Access Compliance Report

Public Rights-of-Way

(Pedestrian Signals)

Intersection ID: N/A	Main Street:	Cross Street: N/A	Location: N/A
ADA ID: 0337F43EEC6B	Signal Type: One Push Button-APS	Overall Compliance: No	Severity Score: BTN 1: N/A BTN 2: N/A No BTN: N/A
Codes/Mitigation Info/Possible Solution		Field Measurements/Component Compliance

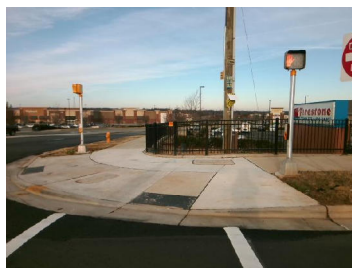
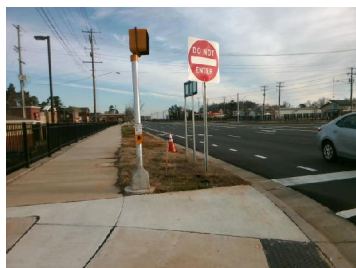
PROW/ADA: TMUTCD 4e.08, R404.2, R404.3, R404.7.2,

N/A	B 1 Clear Xing Direction?	Yes	N/A	B 2 Clear Xing Direction?	N/A
	B 1 Crossing Direction	To E		B 2 Crossing Direction	N/A
No	B 1 DistanceTo XWalk (in)	64.0	N/A	B 2 DistanceTo XWalk (in)	N/A
No	B 1 DistanceTo Curb (in)	74.0	N/A	B 2 DistanceTo Curb (in)	N/A
Yes	B 1 Diameter (in)	2.0	N/A	B 2 Diameter (in)	N/A

Possible Solutions: Replace Signal Push Button With APS Button on New Post. Remove & Relocate Sign.
